Director's Report  
Environment and Planning Services  
Department

## 2.4 DA/204/2007/A - Application to Modify the Design of a new Access Driveway and Intersection required for an Existing Timber Product Manufacturing/Storage Operation

TRIM REFERENCE: DA/204/2007/A - D02803275

FIGURE 3.2 MINIMUM DESIGN FOR A MAJOR ACCESS DRIVEWAY CATERING FOR HRVs AND AVs

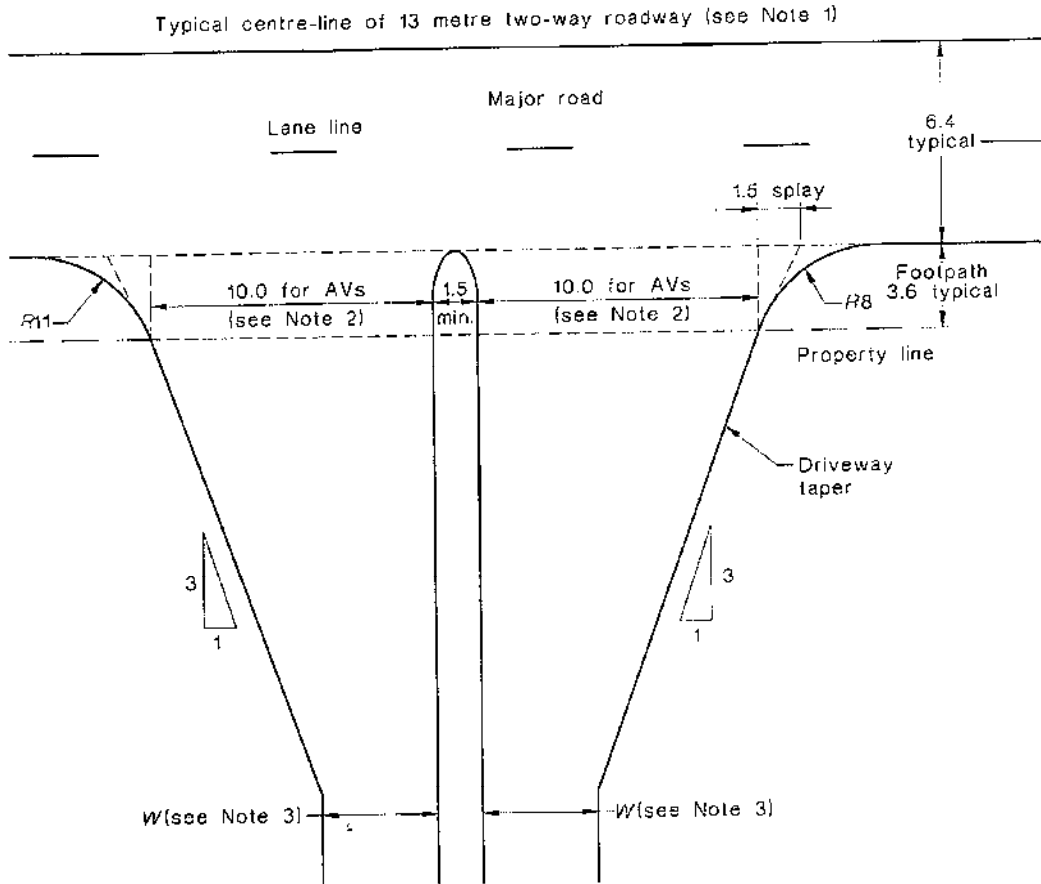
Examination of AS 2890.2-2002 with reference to Figure 3.2 (Minimum Design for a Major Access Driveway catering for HRVs and AVs) identifies that the supporting access driveway Plan 150153 -001 prepared by the applicant's consultant (ADW Johnson) does not comply with the standard. The Australian Standard relates to a major road with a 13.0 metre wide two way (2 lanes in each direction) roadway to provide passing lanes for stationary vehicles into the site access.

The submitted plan prepared by the applicant's consultant details a 7.0 metre wide two way carriageway eliminating any road shoulder widening along Ruttleys Road required to provide sufficient carriageway width to enable the passing of through traffic around right turning ingress & egress and left turning traffic.

*However, it is agreed with the applicant's consultants that Figure 3.2 ("Minimum design for a major access driveway catering for HRVs and AVs") is the correct diagram to use in lieu of Figure 3.1 – "Minimum design for an access Driveway on a minor road catering for HRVs and AVs".*

*Given the use of the road, evidenced by the significant volume and speed of through traffic, Rutleys Road should be considered as a "Major road" in terms of facilities that are required and hence the use of Figure 3.2 is more appropriate, than Figure 3.1, when considering Australian Standard AS 2890.2-2002.*

*The plan attached in the consultant's submission is not in accordance with Figure 3.2 of Australian Standard AS 2890.2-2002. The southbound pavement, shown on the diagram submitted by the consultant, is only being 3.5 metres wide. Figure 3.2 is based on a pavement width of 13 metres and therefore the southbound pavement should be 6.5 to 6.6 metres wide. This pavement width (6.5 to 6.6 metres for the southbound carriageway) is no different to the widening identified in Austroads 2009, Figure 7.5, "Basic right (BAR) turn treatment on a two-lane rural road". Figure 7.5 in Austroads 2009, identifies a requirement for the southbound pavement to be a minimum of 6.5 metres wide. Also Figure 3.2 (AS 2890.2-2002), identifies provision for a left turning lane. This also is not shown on the diagram submitted by the applicant's consultant.*

**“9 The driveway/intersection onto Ruttleys Road shall be relocated approximately 135 metres south of the existing unsealed site access.**

- *The design shall be prepared in accordance with Austroads 2009 "Guide to Road Design – Part 4A: Unsignalised and Signalised Intersections "BAR" treatment on a major road and Wyong Shire Council's Development Control Plan 2005, Chapter 67 Engineering Requirements for Development.*

Figure 4.1: Rural basic BA turn treatments

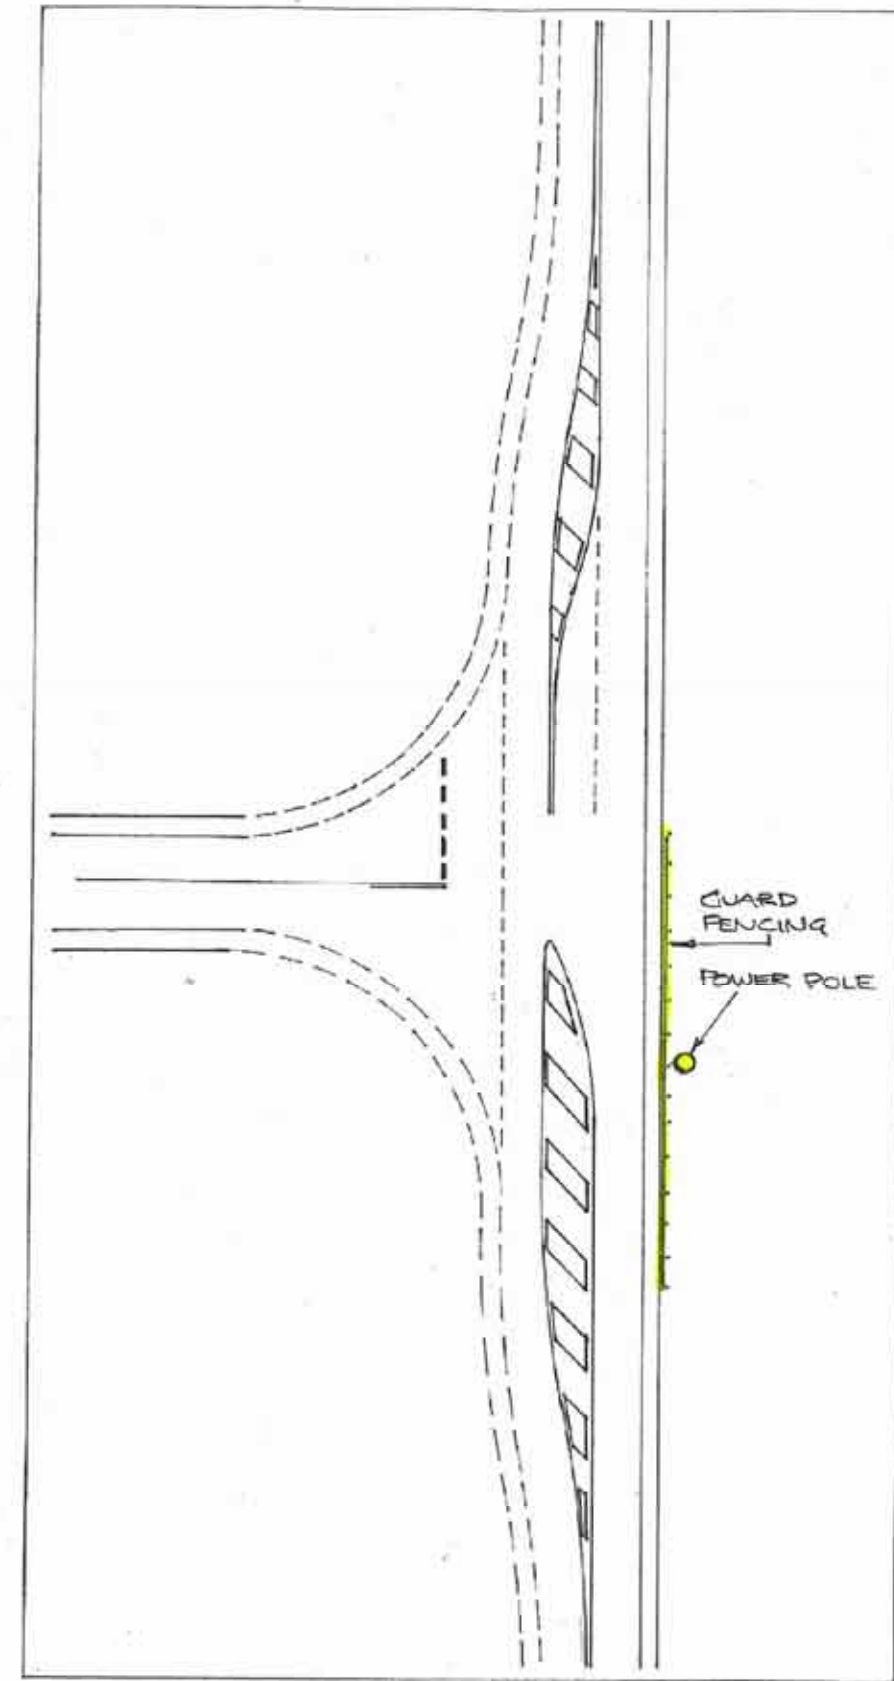
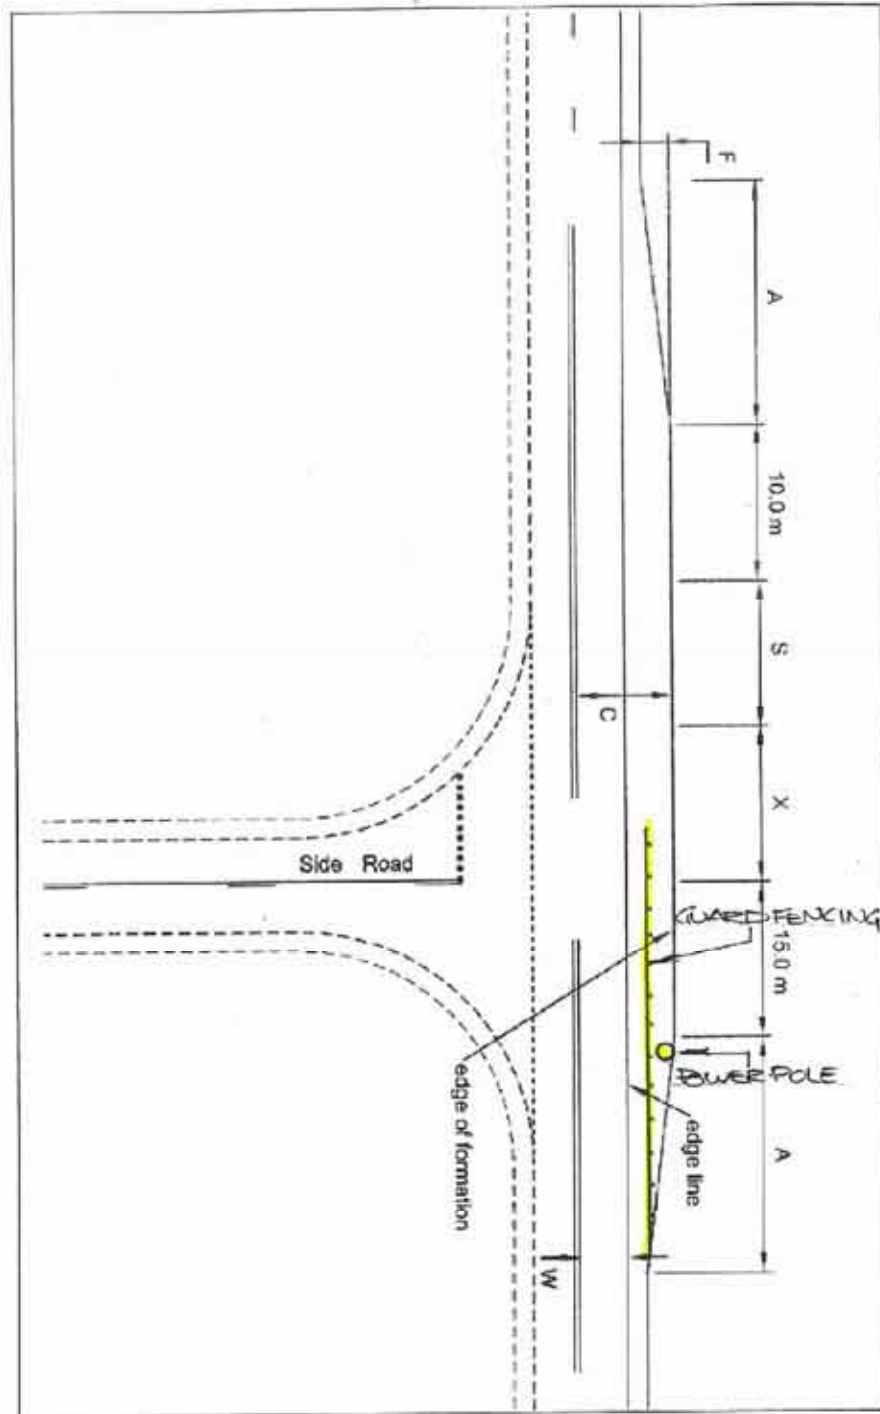
*As Rutleys Road is a rural road, Austroads 2009 is considered to be the correct document to use in identifying requirements for the development, relating to the accessway intersection. Section 7.5.1 of the Austroads document identifies that the treatment identified in Figure 7.5 is applicable to "local access points", which is the type of access under consideration.*

*In accordance with Austroads 7.5.1, consideration should be given to the "substantial speed reduction" that would occur in the vicinity of the driveway when assessing the requirements for the dimensions of the intersection being designed in accordance with Figure 7.5.*

- *The design of the intersection should take into account the location of the existing large power poles and guard fencing. Note: The widened pavement required in accordance with the BAR (Austroads Figure 7.5 treatment) should be formed, sealed and the outside edge line a sufficient offset from any guard fencing.*

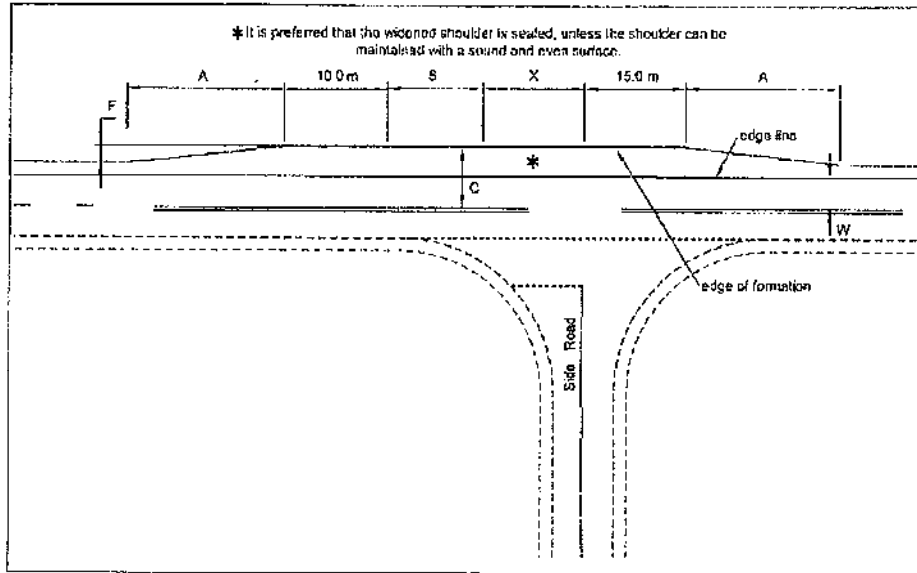
4. Existing daily traffic flows are in the order of 8,693 vehicles per day (2010 survey data). Allowing for the peak hour flows to typically be between 8 and 12 percent of the daily flows, this would indicate peak hour flows of between 696 and 1,043 two-way.

5. The traffic flows associated with the development on the site are very low, in the order of 6 heavy vehicles per day. Neormap photography indicates that truck and dog combinations access the site and these vehicles generally accelerate and deceleration at low rates. The volume of vehicles entering and exiting the site does not take into account staff movements in and out of the site. A review of Neormap satellite photography indicates a substantial number of cars also located on the site. Photo dated 26<sup>th</sup> October 2010 indicates some 20-25 vehicles parked on site and it is reasonable to assume a large number of these would arrive and depart during the morning and afternoon peak periods associated with start and finish of work on site.

From our findings, the following recommendations with regard to the access are made:

- a) The access to the site should be designed in accordance with the requirements for a speed limit of 90 km/h, to ensure road safety is maintained along this section of the road. The accident data shows that there have been a number of accidents along this length of Ruttleys Road which is possibly reflective of both the road alignment as well as the actual speed that drivers are comfortable with on this road.

- c) The appropriate design standard to use in this instance is Austroads Part 4A: Unsignalised and Signalised Intersections. With regard to Figure 4.9 of this publication, taking into account the two-way peak hour flow along Ruttleys Road (between 696 and 1,043) the minimum intersection layout to be provided is a type BAR. This allows for shoulder widening to allow for the southbound traffic movement to pass any vehicle waiting to turn right into the site access road. This type of intersection layout will avoid rear end type accidents that can occur on this type of road, given the traffic volumes and the vehicle speeds.
